NEW ELEMENTARY SCHOOL
9801 HIGHLAND KNOLLS DR
BAKERSFIELD
CALIFORNIA
93306

NEW MIDDLE SCHOOL
4115 VINELAND ROAD
BAKERSFIELD
CALIFORNIA
93306

E-132P
SHEET OF

LIGHTING PLAN BUILDING P

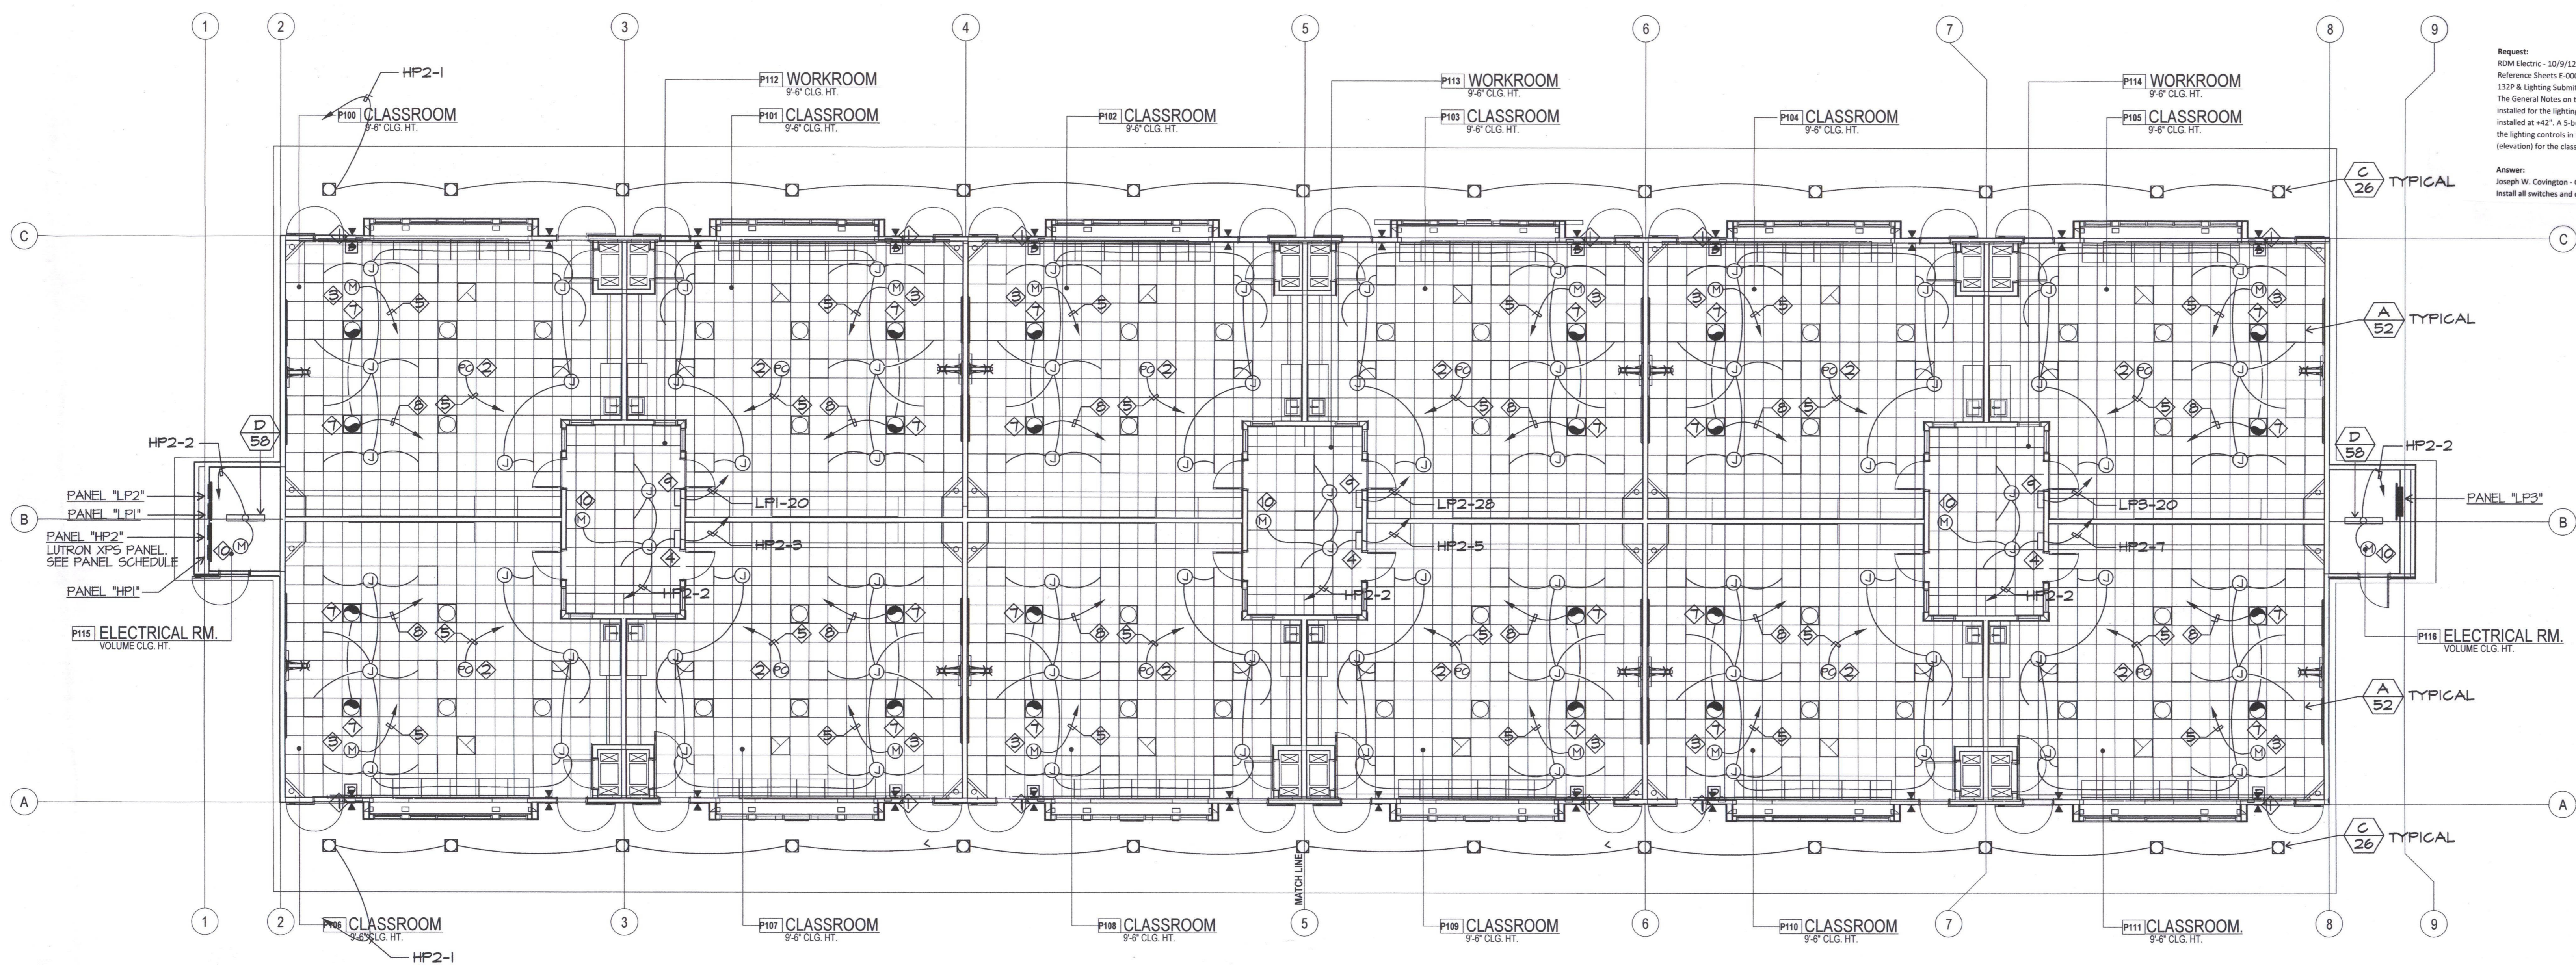
RFI 163

Request:
RDM Electric - 10/9/12
Reference Sheets E-000, E132C, E-132D, E132E, E-132F, E-132G, E-132H, E-132P & Lighting Submittal
The General Notes on the Electrical Plans show the lighting dimmers to be installed at +48" to top of box and the light switches to be installed at +42". A 5-button Lutron wall station is shown to be installed for the lighting controls in the classrooms. Please provide mounting height (elevation) for the classroom lighting control wall stations.

Reference RFI #252 & Sheets E132C, E132D, E132E, E132F, E132G, E132H, E132I & E132P
For the response to RFI #252, the skylights in the classrooms are to be controlled via an Energi Savr Node. However, per the electrical code, the skylights appear to need separate DC switching to be controlled, which is not shown on the drawings. The plans only show to supply 120V to the skylights via the Energi Savr Nodes. Do the classrooms need DC switching to be added as a means of controlling the skylights? If so, please advise on the requirements.

Answer:
Joseph W. Covington - Ordiz-Melby (10/11/12)
Install all switches and dimmers at +42" to the center of the box.

RDM Electric - 9/19/13
John Maloney - JMPE - 9/19/13
Contact closure on Energi Savr Node will operate skylight shutter. We verified this with Sotabue and Lutron.
